Reviewer #1

Baur et al. evaluate the potential for solar photovoltaic and concentrating solar power under three future climate scenarios: SSP5-8.5, SSP2-4.5, and G6sulfur which reduces the climate forcing from SSP5-8.5 to SSP2-4.5 using stratospheric aerosol injection (SAI). They find the resource potential for both technologies reduces under the geoengineering scenario. The results confirm the one study that has previously investigated SAI impacts on solar energy technologies, from Smith et al. (2017).

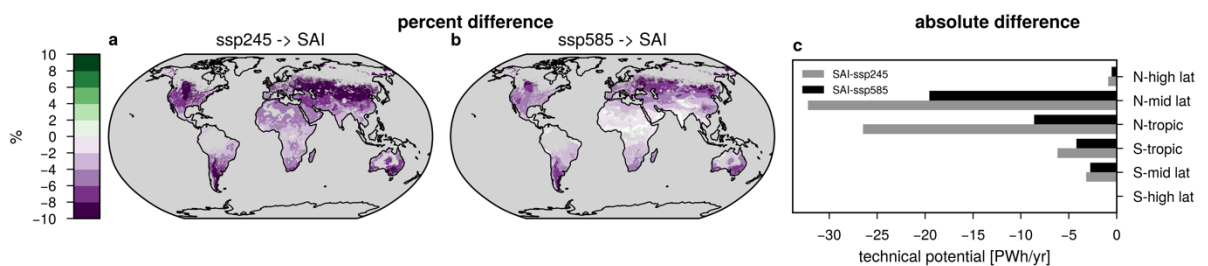
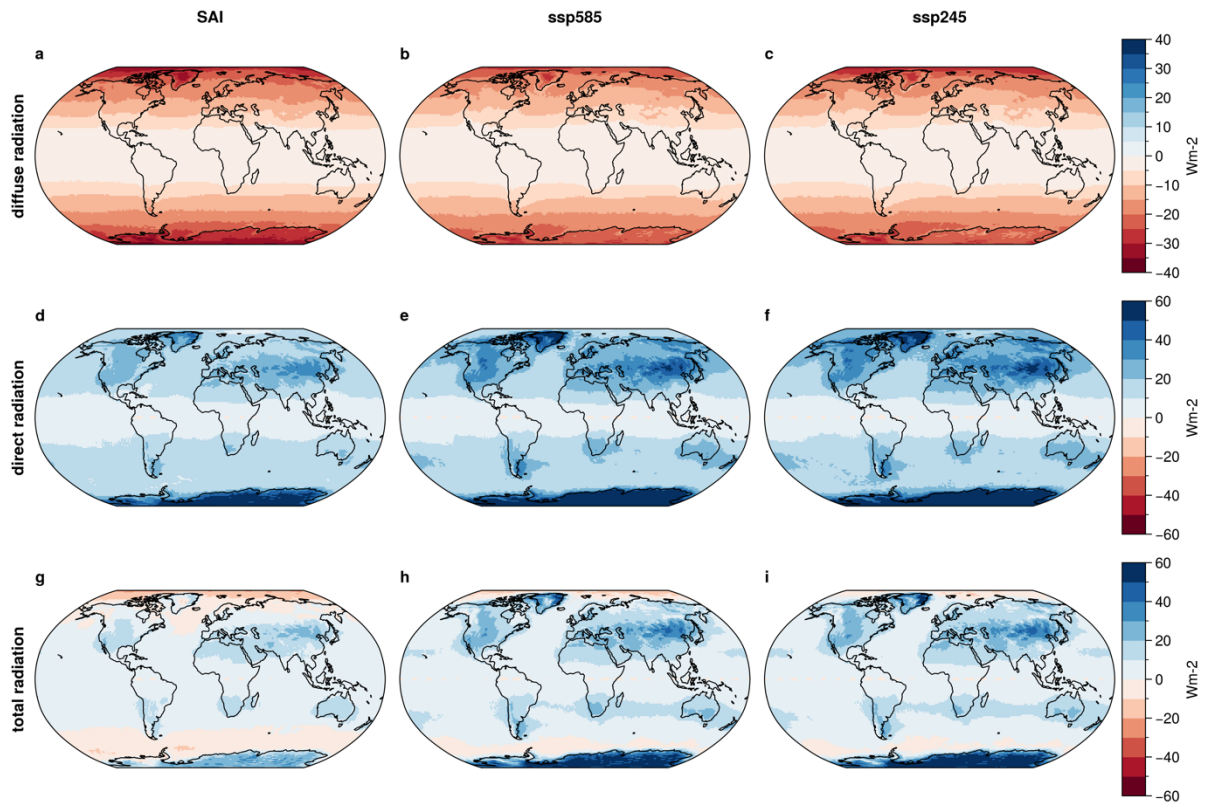
1. There does not appear to be a consideration of the solar geometry in the equation for PV. For CSP, the factor of the cosine of the zenith angle cancels out (Smith et al. eq. (7), eq. (9)) so providing the FLH equation is correctly defined in your paper then this is OK. However for PV, the direct/total irradiance is important, as well as the orientation of the solar panel, as to the amount of radiation it receives and the panel temperature which affects its efficiency. In eq. (1), the power output expected would be greater than predicted from the climate model value of RSDS, since this would be a horizontal irradiance value, and a real-world solar plant operator would angle the panels appropriately to maximise the incident irradiance on the panel. Perhaps these corrections are already baked into the equations you use. It would be good to confirm.

We agree that the consideration of the solar geometry and the exposition of the panels is a better representation of real-world solar farm installations. In our revised manuscript we added another subchapter to the methods and results showing PV potential when solar geometry and panel inclination are accounted

for and discuss these additional results in the following parts of the paper. Unfortunately, we could not update the entire analysis of our study because a processed decomposition of the single physical drivers (Figure 3) is not possible for us under separation of direct and diffuse light (the model doesn't produce the RSDSdiff-clear-sky variable as a standard output). The main conclusion of the paper does not change with this updated version of the PV potential calculation but it shows even larger relative and absolute reductions in the high latitudes than for horizontally aligned panels (Figure 1). This is because the tilt of the panel increases the amount of direct radiation that can be harvested. However, SAI modifies the fraction of direct and diffuse radiation to entail a larger diffuse fraction and therefore the advantage of the tilt is reduced under SAI versus the SSP scenarios. Hence, relative reductions in high latitudes under SAI that already exist for horizontally aligned panels are further increased for tilted panels.

We added a figure to the Supplementary Information to illustrate the effect of the tilt and solar geometry on the direct and diffuse radiation that reaches the panels surface (Figure 2).

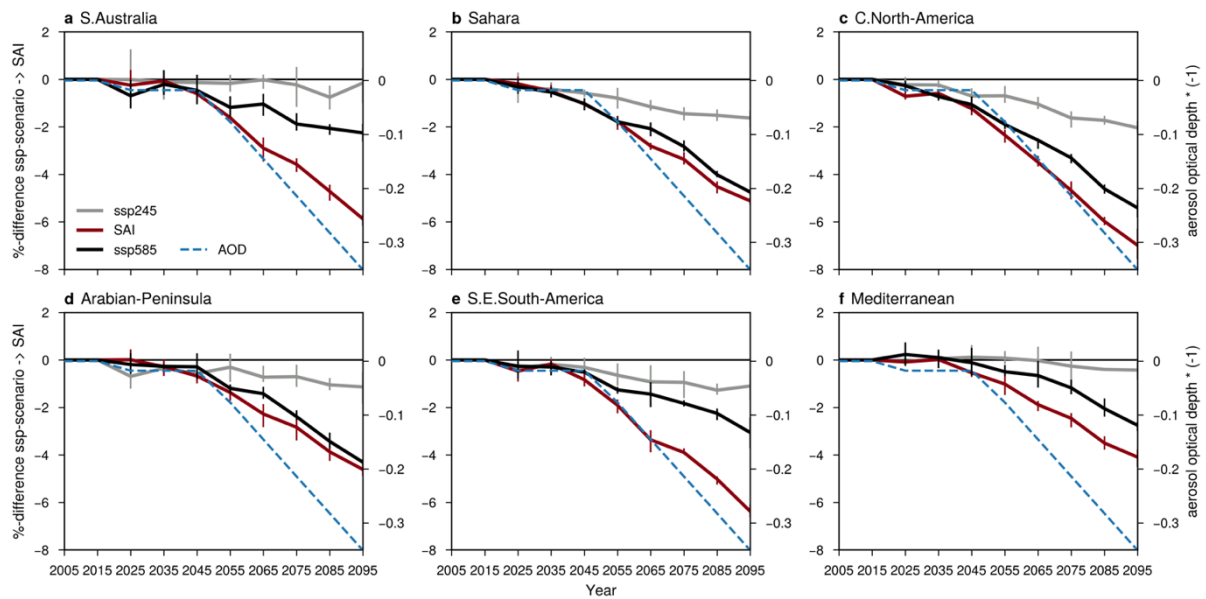
2. Around line 272 there is a "quasi-linear" relationship for reduced potential. It looks fairly linear in time (fig. 6), but since we don't have the SAOD plot we don't know if it is linear in AOD. This would be quite a useful result to verify as if it is linear, it would be easy to transplant into an economic or integrated assessment model.

We agree and added the 10-year global mean AOD to Figure 7 (in the manuscript; Figure 3 in this response).

“Figure 7 illustrates the temporal evolution of the relative difference between the three scenarios and present-day values with the increase in SAI deployment intensity over time. In the first four decades, the scenarios differ only slightly, but the gap in potential starts to widen as time goes on. The quasi-linear increase in the gap between SAI and the SSP-scenarios in some regions indicates that, in these areas, the reduction in PV potential strengthens with increasing global mean aerosol optical depth.”

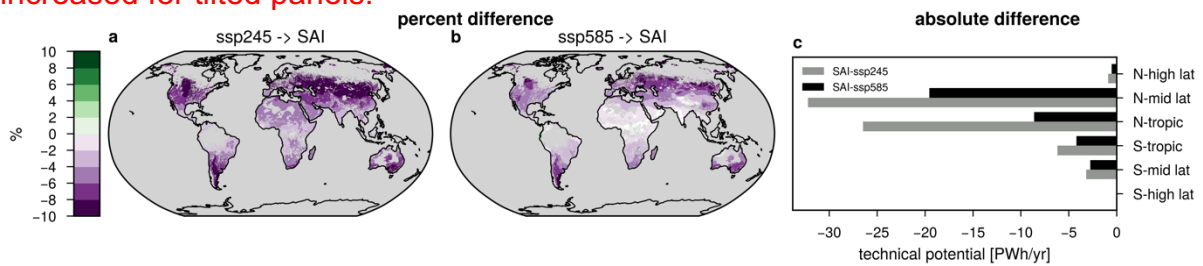
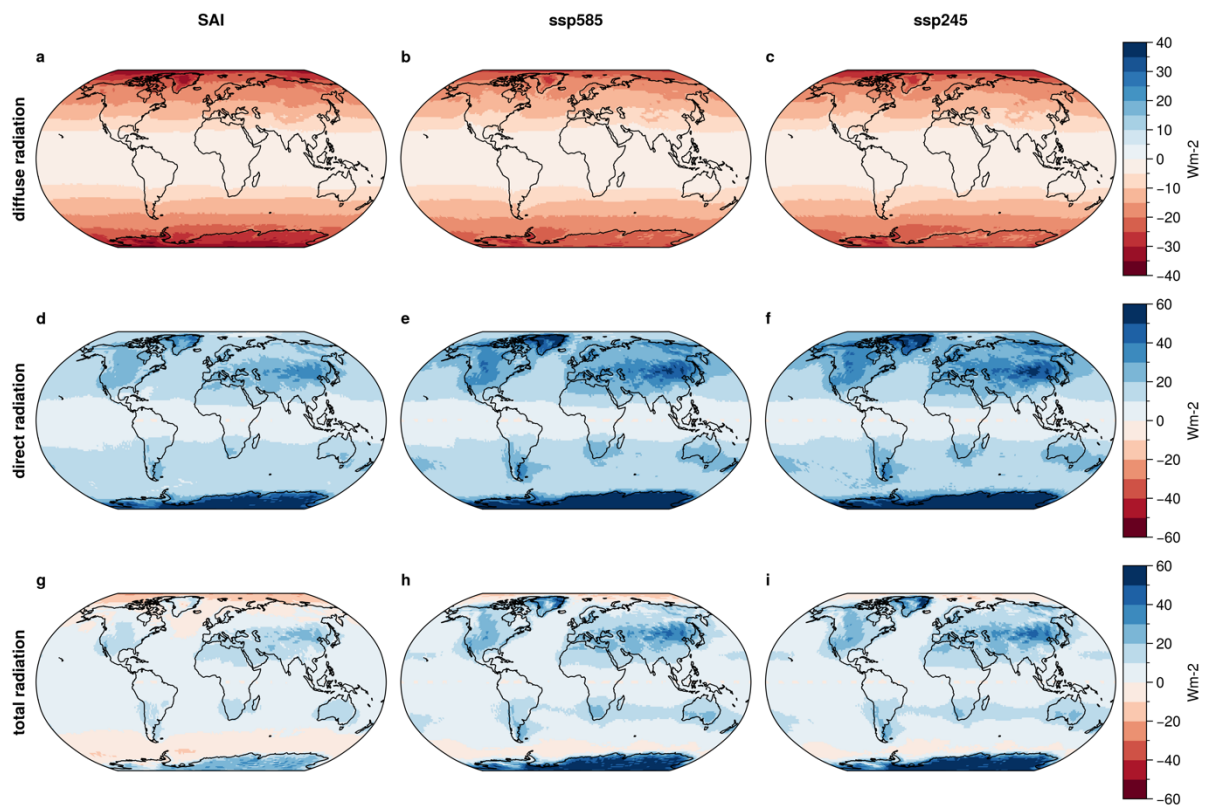
Equation 1: just to confirm that PV-TP takes direct and diffuse radiation with the same efficiency, since RSDS is used. Does PV panel need to adjust certain setting for better performance under cloudy days?

Equation 3: should c_3 be different for direct and diffuse radiation?

Yes, PV-TP takes direct and diffuse radiation with the same efficiency. On cloudy days panels would likely adjust the tilt of the panel.

We have added another mode of PV-TP calculation (PV-TP_{fixed}) to the study that takes direct and diffuse radiation into account separately by considering solar geometry and a tilt of the panel. The main conclusion of the paper does not change with this updated version of the PV potential calculation but it shows even larger relative and absolute reductions in the high latitudes than for horizontally aligned panels (Figure 1). This is because the tilt of the panel increases the amount of direct radiation that can be harvested. However, SAI modifies the fraction of direct and diffuse radiation to entail a larger diffuse fraction and therefore the advantage of the tilt is reduced under SAI versus the SSP scenarios. Hence, relative reductions in

high latitudes under SAI that already exist for horizontally aligned panels are further increased for tilted panels.

We added a figure to the Supplementary Information to illustrate the effect of the tilt and solar geometry on the direct and diffuse radiation that reaches the panels surface (Figure 2).
